# UNITED STATES PATENT AND TRADEMARK OFFICE

APPLICATION NO.	FILING DATE	FIRST NAMED INVENTOR	ATTORNEY DOCKET NO.	CONFIRMATION NO.
10/091,788	03/06/2002	Qing Chen	AINNO.0104	8949
22858	7590	03/11/2005	EXAMINER	
CARSTENS YEE & CAHOON, LLP P O BOX 802334 DALLAS, TX 75380			NGUYEN, VINCENT Q	
			ART UNIT	PAPER NUMBER
			2858

<b>Office Action Summary</b>	<b>Application No.</b> 10/091,788	<b>Applicant(s)</b> CHEN ET AL.	
	<b>Examiner</b> Vincent Q. Nguyen	<b>Art Unit</b> 2858

## DETAILED ACTION

#### Feature claimed

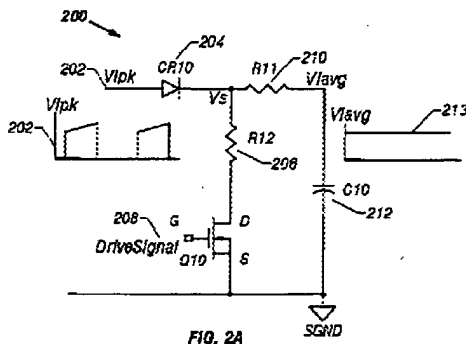
The only difference between Hirst and the invention claimed is that the claim recites the resistor coupled to the cathode of the diode in place of the resistor coupled to the anode of the diode.

#### Prior art applied in the rejection

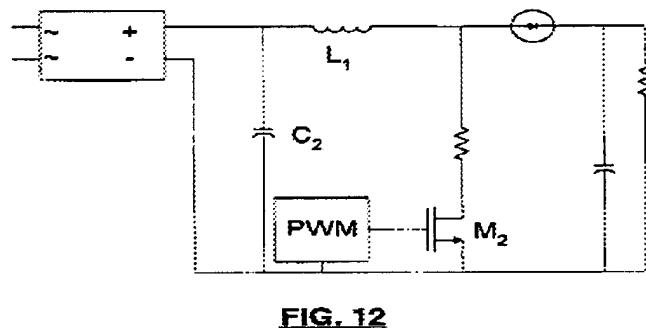
Regarding claim 1, Hirst discloses a device comprising (Figure 12) (a) a diode; (b) a resistor in series with a switch (M2), with the resistor coupled to the diode; (c) an RC filter in parallel with the resistor and switch of element (b).

It would have been obvious to one of ordinary skill in the art at the time the invention was made to couple the resistor to the cathode of the diode instead of coupling to the anode as taught by Hirst because coupling the resistor before or after the diode (i.e. couple the resistor to anode or couple to cathode) the function of the circuit does not change since the current, either being rectified (Resistor couples to the cathode) or not (couple to the anode), flows through the switch and will be modulated to obtain desired results.

Regarding claim 2, Hirst discloses the switch (M2) is synchronized with an incoming peak current signal (PWM).

Regarding claim 3, Hirst discloses an average current signal (See also figure 10; figure 13, column 13, lines 35-39) is sensed across a capacitor (Current is sensed through the shunting resistor paralleling with capacitor on the right hand side of M2).

Regarding claim 4, Hirst discloses the RC filter (Capacitor and resistor parallels in the right hand side of the resistor and switch M2) smoothes an average current signal (The smoothing current signal is true not only for the prior art of Hirst but also true for every prior art having filter).
